**Virginia Board of Housing and Community Development
 CODES AND STANDARDS COMMITTEE
 2015 CODE CHANGE CYCLE – BOOK 6
 September 18, 2017**

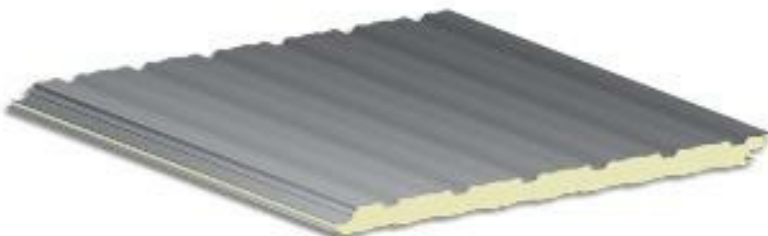
Section 2603.4.1.4 is essentially a "carve out" for a particular type of building (e.g., metal storage buildings) and type of exterior wall construction (where the exterior wall itself is metal-faced panels without thermal barriers). Refer to the images below:

However, the vast majority of one-story buildings throughout the commonwealth is not or would not be constructed that way, thus, **nearly all non-Type V one-story buildings would have to comply** with the NFPA 285 test.

CR-R905.2.8.5 cdpVA-15

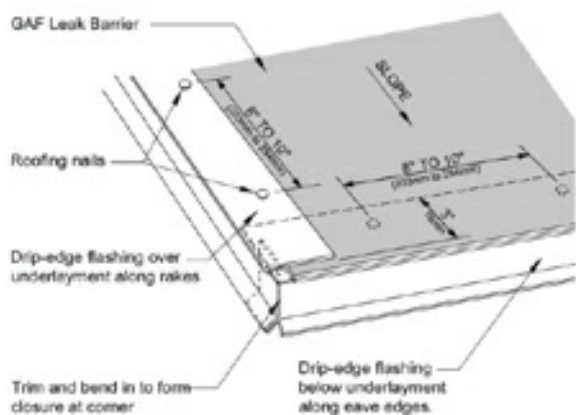
R905.2.8.5 Drip edge. [REJECT DELETION]
